Campaign No. 2021050005 June, 2021

SUBJECT: **Model 907 Sprinter, Model Year 2019-2020**
Install Additional Retaining Ring on
Brake Pedal Bracket

Mercedes-Benz AG (MBAG) the manufacturer of Mercedes-Benz and Freightliner vans, has determined that on certain platform 907 (VS30) Sprinter vehicles, the retaining washer on the bolt that connects the brake pedal to its bearing block could come loose. If the retaining washer comes loose, over time it could detach from the bolt, and in the worst case and with ongoing use of the brake pedal, the bolt may work its way out of the bearing block on one side. If this occurs, the brake lamp switch may become permanently activated even when the brake pedal is not pressed. If the brake lamps are permanently illuminated, it would not be possible for following traffic to determine the braking intention of the vehicle, which could increase the risk of a crash. An authorized Mercedes-Benz or Freightliner dealer will install an additional retaining ring on the bearing bracket of the brake pedal.

D29.10-A008-76

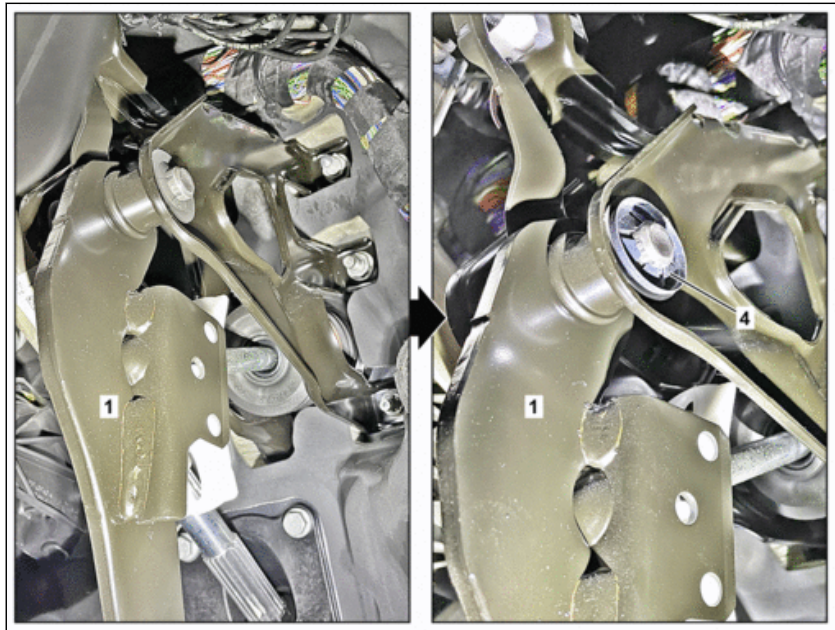
Before/after

- 1 Brake pedal
- 4 Retaining ring
